August 22, 2012

CP2104 Errata

D1. ROM Programming Voltage

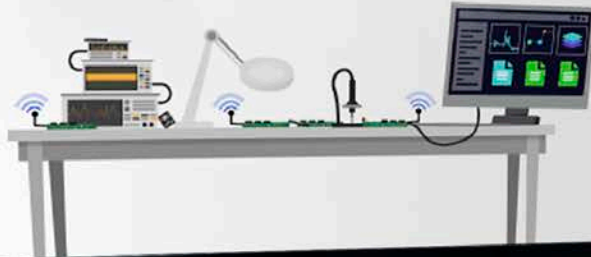
Description: The data sheet incorrectly indicates that VDD must remain at 3.3 V or higher to successfully write to the configuration ROM. Instead, the voltage on the VIO pin must remain at 3.3 V or higher when writing to the configuration ROM.

Impact: For systems that connect VDD and VIO together, there is no impact. For systems that have a separate voltage source for VIO and are configuring the ROM in-system, VIO must remain at 3.3 V while programming is in progress.

Resolution: This note will be fixed in the Revision 1.1 of the CP2104 Data Sheet.
